4. Case No. REZ20-0016

An application for a rezoning of approximately 48.75 acres of land from Interim Development Single-Family (ID-RS) to Low Density Single-Family with a Planned Development Overlay (OPD/RS-5).

Re:	REZ20-0016 – Hickory Trail Rezoning Resubmission
From:	Ray Heitner, Associate Planner
To:	Planning & Zoning Commission
Date:	May 6, 2021

PRELIMINARY OPD AND SENSITIVE AREAS DEVELOPMENT PLAN **HICKORY TRAIL** IOWA CITY, IOWA

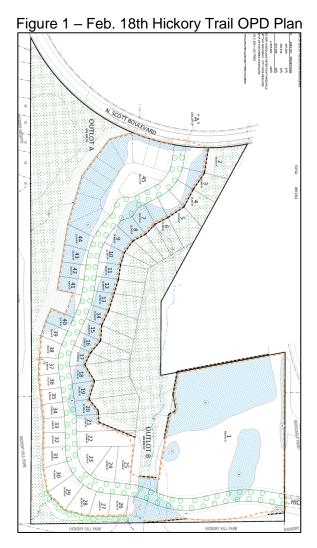
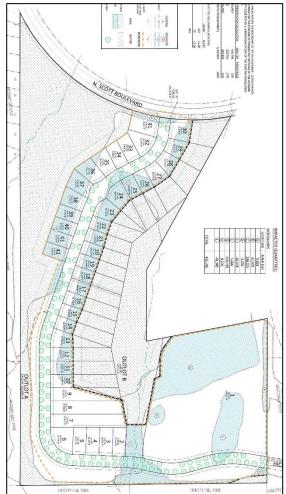
The most recent OPD Plan contains the following changes to the layout from the previous plans that were reviewed by the Commission:

- 1. The removal of the condo-style housing in the northwest portion of the plan area. The revised Plan contains 41 lots intended for detached single-family housing.

- 4. Per staff, the applicant has added a third pedestrian crossing, which will be adjacent to the proposed traffic circle.
- 5. Per staff, the applicant has also added an additional sidewalk accessing the senior living facility from the public sidewalk on the east side of the facility.

Figures 1 and 2 below show the change in layout from the original OPD Plan (Figure 1) that was presented to the Planning and Zoning Commission on the February 18th meeting, versus the current plan (Figure 2) presented on the May 6th meeting.

Figure 4 – April 29th Hickory Trail OPD Plan

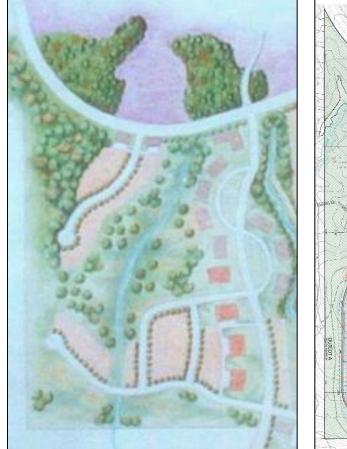
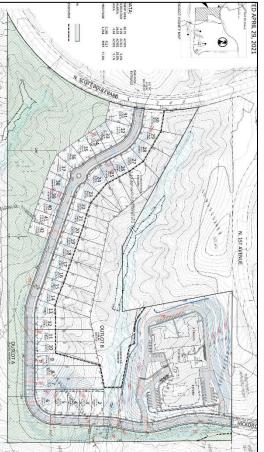
Figures 3 and 4 show a comparison between the Bluffwood Neighborhood conceptual vision from the Northeast District Plan and the current proposed OPD Plan. While the proposed OPD Plan uses a through street, as opposed to two cul-de-sacs, the current proposed OPD Plan features a

similar single-loaded street frontage, with most of the central and southern portions of the development showing housing only on one side of the street.

Figure #2 - Bluffwood Neighborhood Map

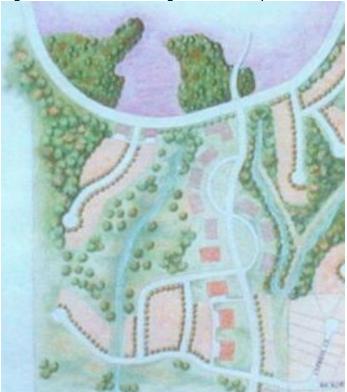
The Bluffwood Neighborhood map (Figure #2 below) shows two cul-de-sac streets within the subject property. One cul-de-sac is stemming southward from Scott Boulevard, while the other is a westward continuation of an extension to Hickory Trail. Housing is shown mostly on both sides of the street on the northern cul-de-sac, with an exception for the southwestern portion of the cul-de-sac. The southern cul-de-sac shows housing only on one side of the street. A woodland buffer is shown on the map, but dimensions for how wide the buffer are not provided.

Rather than constructing two separate cul-de-sacs, as is shown in the Plan, the applicant is intending to build one continuous through street between 1st Avenue and Scott Boulevard. However, section 15-3-2A-4 of the City Code states the following "Use of cul-de-sacs and other roadways with a single point of access should be avoided. Cul-de-sacs will be considered where it can be clearly demonstrated that environmental constraints, existing development, access limitations along arterial streets, or other unusual features prevent the extension of the street to the property line or to interconnect with other streets within or abutting the subdivision." In this instance, the applicant has demonstrated that a through street can be provided in this location without impacting the protected slopes to the east of the proposed street extension, or the wetlands that exist on the property.
